# Safety Recall Circular

Code: **66D6**

**Subject: 2007-2009 Touareg 2  
Roof Edge Spoiler**

**REVISED**  
January 2018

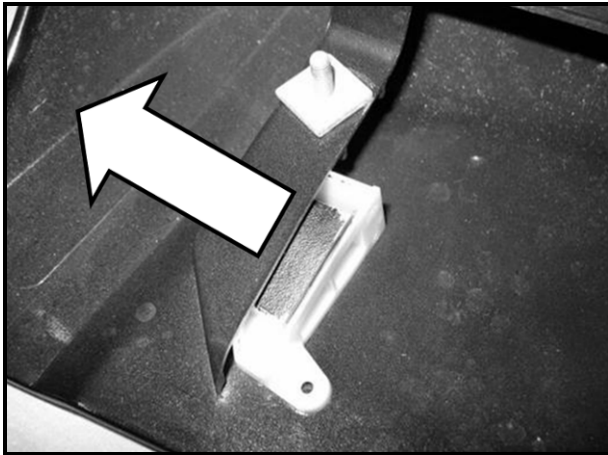
**Updated primer part number and increased primer drying/flash off time.**

- ⇐ Prime the three reinforcements (7L6 827 045) with applicator D 009 500 25 and paint primer D 181 220 A1 from above and below in the indented area and allow to completely dry – approximately 30 minutes
